Schedule B Data Sheet

Location Melby Street, from Anderson Drive to Hastings Way, within Section 34, T 28

Improvements Water Main & Services, Sanitary Sewer & Services, Storm Sewer, Grade,

Melby Street (Anderson Drive to North Hastings Way)

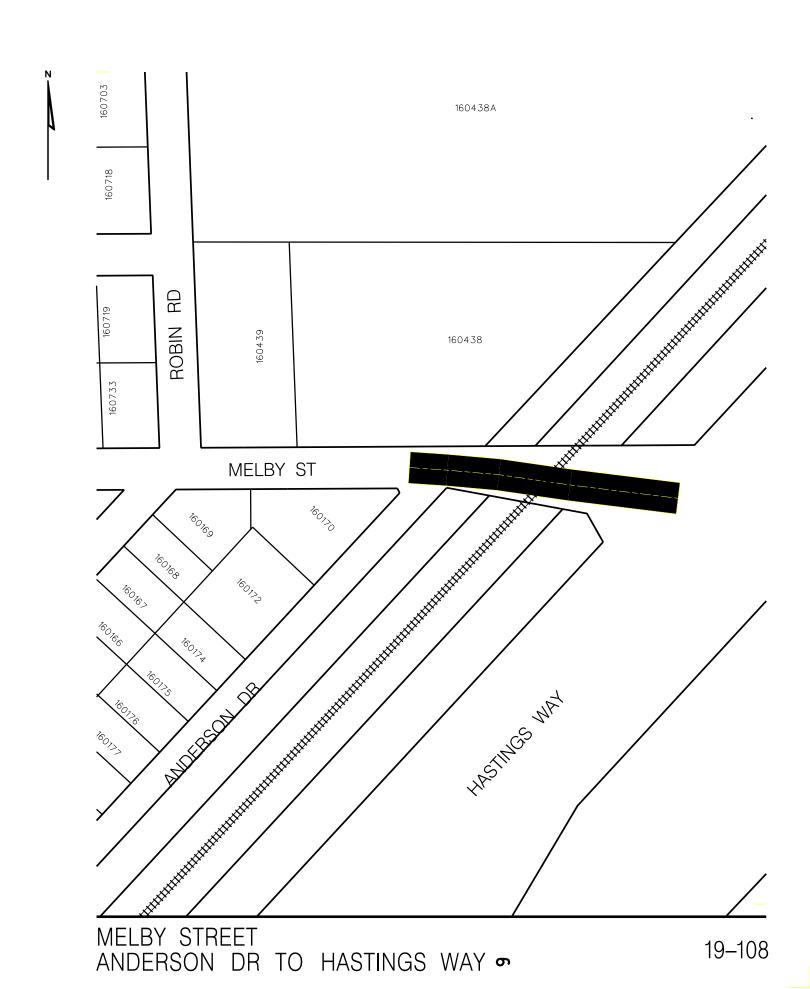
This street is identified as a primary/regional bicycle route in the City's Bicycle and Pedestrian Plan which also connects with the City's recreational trail to the east. A gap in the sidewalk system is also identified in this area. The Committee supports the plans to reconstruct this section of Melby Street which includes the installation of sidewalk on both the north and south sides of the street. The Committee noted that the installation of the sidewalk should be placed to accommodate both those walking along the sides of the street and those accessing the trail. Desire pathways exist along both sides of the street denoting the areas commonly used by pedestrians and bicyclists. The Committee also suggested that consideration be given to providing an enhanced crosswalk treatment where the

trail crosses Melby Street (similar to Eddy Lane). Finally, the Committee also noted that the City should plan for the eventual striping of bicycle lanes along this section of street when Melby Street west to the airport is reconstructed with bicycle lanes since it is identified as a primary/regional bicycle route.

Melby Street is identified as a primary/regional bicycle route in the City's Bicycle and Pedestrian Plan, which also connects with the City's recreational trail to the east. BPAC supports the plans to reconstruct Melby Street with sidewalk along both the north and south sides of the streets. BPAC also recommended enhanced crosswalk treatment where the Old Abe Trail crosses Melby Street and to explore expanded bike lane striping in the future.
